JOINT REGIONAL PLANNING PANEL (East)

JRPP No	2016SYE012
DA Number	486/15
Local Government Area	North Sydney Council
Proposed Development	Demolition of existing office building and the construction of a mixed use development comprising basement levels, retail / commercial floor space, and 415 residential apartments
Street Address	168 Walker Street, North Sydney
Applicant/Owner	Aqualand Pty Ltd
Number of Submissions	Thirty nine (39)
Regional Development Criteria (Schedule 4A of the Act)	Capital Investment Value > \$20M
List of All Relevant s79C(1)(a) Matters	North Sydney LEP 2013 - Zoning – B4 Mixed Use North Sydney DCP 2013 SEPP65 SEPP 55 - Contaminated Lands SREP (2005)
List all documents submitted with this report for the panel's consideration	Plans Clause 4.6 request Conditions
Recommendation	Approval
Report by	Geoff Mossemeneer, Executive Planner, North Sydney Council

Figure 4: Indicative built form of a height compliant scheme

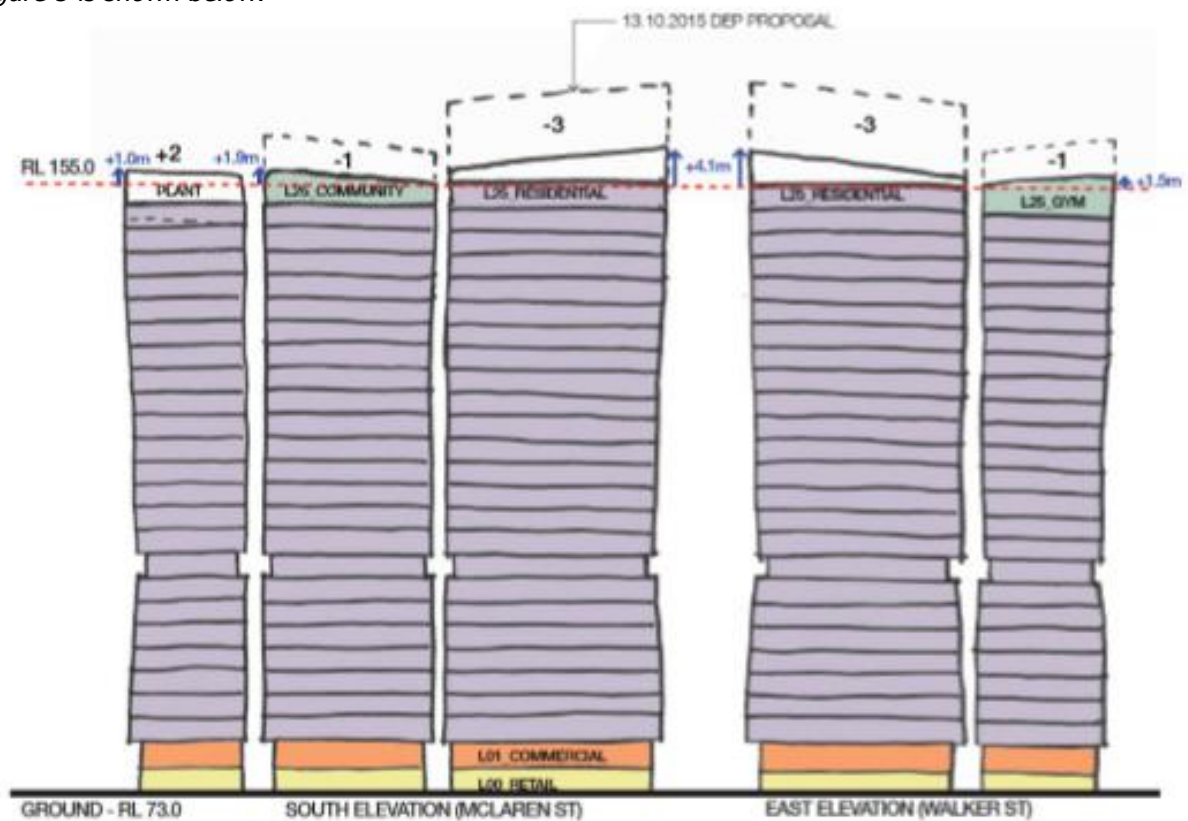
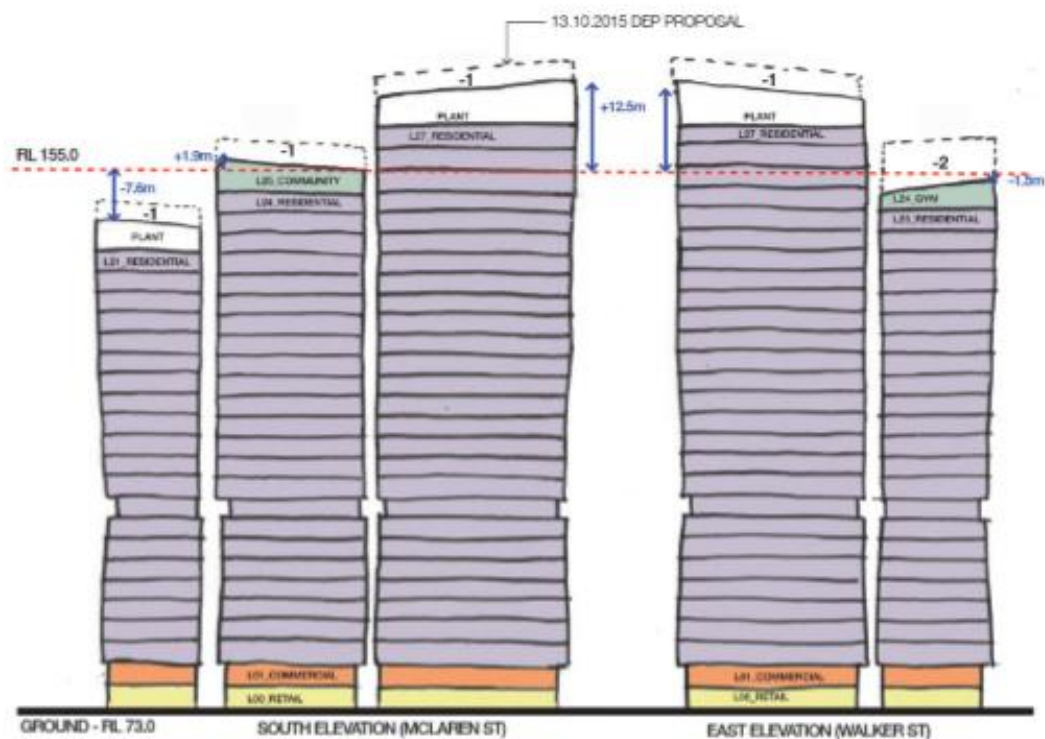
Visual impacts: Due to the non-complying components of the building being located on the south eastern section of the site there is not a significant difference in visual impacts between the proposed building a complying building. The reduced height, below the maximum RL, of tower pod 1, closest to the western boundary, and tower pod 4, closest to the northern boundary results in an improved outcome with the adjoining properties, with height redistributed to the corner pod 3. The design is a conscious effort to take away building height – compliant building height – from the sensitive side boundaries and redistribute this floor space and height on to the less sensitive section of the site. The upper levels on tower pod 3, above the maximum RL contain 2 residential levels and building plant and represent floor space taken out of tower pods 1 and 4. The upper levels of tower pod 3 will not present as an imposing visual mass when viewed from the surrounding area, due to the setbacks of the building from McLaren and Walker Streets and the relatively modest increase in scale above a complying height.

A comparison between a height "compliant" built form, shown in Figure 4 and the proposal, shown in Figure 5 is shown below.

Figure 6: shadow diagram relating to residential area and public open space

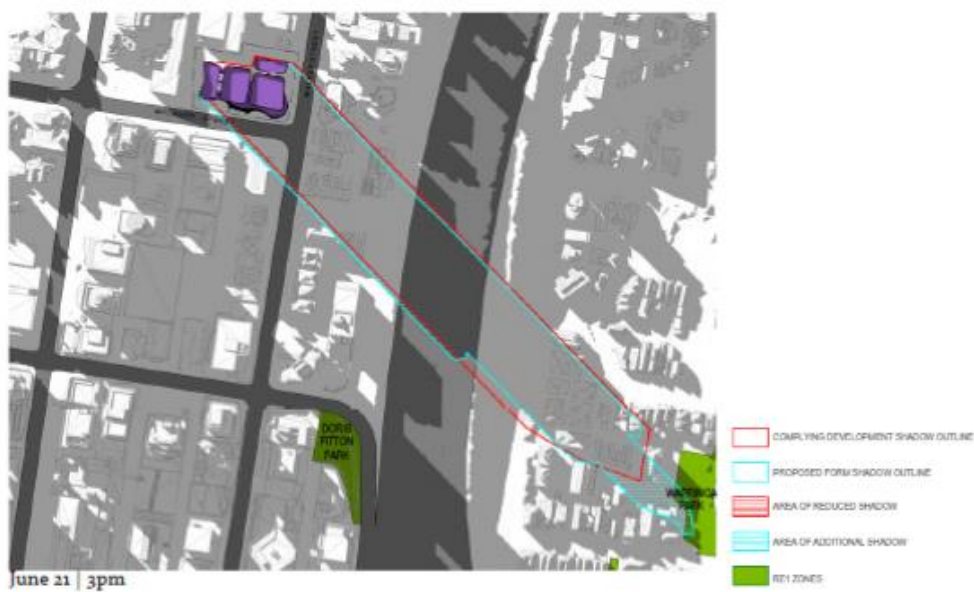
Overshadowing impacts: Due to the stepped and sculptured built form, with sections of building under and over the maximum height standard, there are moderately different overshadowing impacts as compared with a fully compliant building uniformly built to the maximum. The variation in building height across the site, with some sections of the building below the maximum height standard, and some above, results in some minor variations to a "compliant" shadow impact. The architectural drawing package includes detailed analysis, with the only potential impact on residential and public open space zoned land being to the east of the North Sydney centre. Information taken from the architectural drawings is included below in Figure 6.

The slightly extended shadow, resulting from that section of the building above the height standard, falls within existing shadows cast in the afternoon mid-winter. There is no net increase in shadow impact.
